**Florida
Power**
CORPORATION

November 22, 1988
3F1188-11

Subject: Crystal River Unit 3
Docket No. 50-302
Operating License No. DPR-72
Additional Information on ATWS Design

CR-3 EFIC POWER SUPPLY
CONFIGURATION & OPERATIONAL CHARACTERISTICS

The logic development of the EFIC inputs from the ARTS Main Feedwater Pump trip circuitry and the AMSAC loss of Main Feedwater flow circuitry is shown in a simplified logic diagram (Figure 1 Attachment 2) included with this letter.

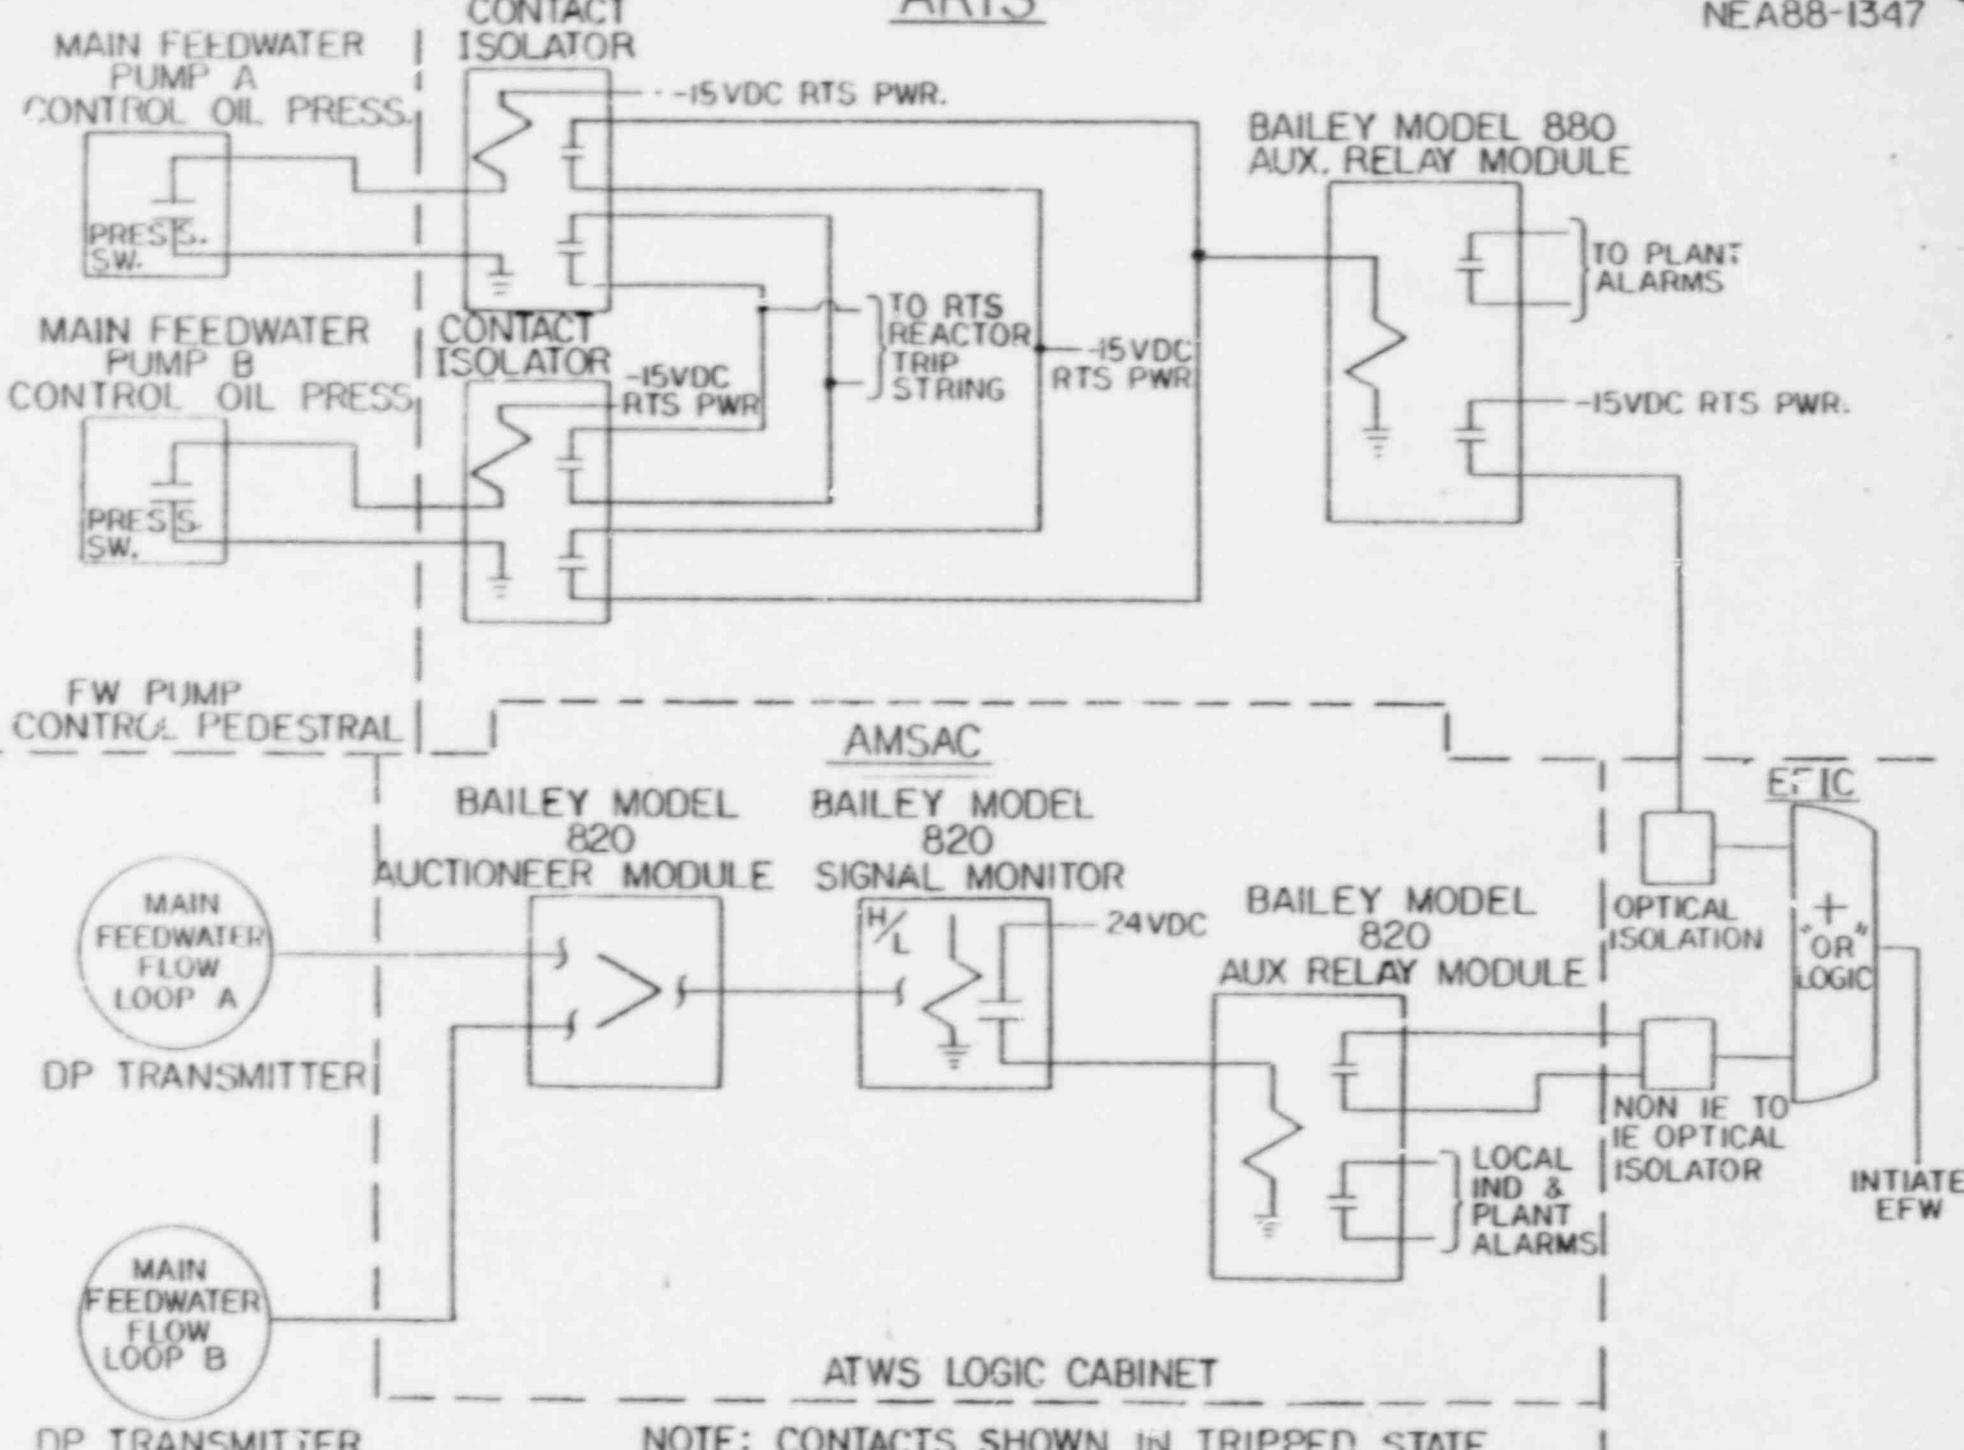
IV. EFIC/RTS Logic for Emergency Feedwater Initiation
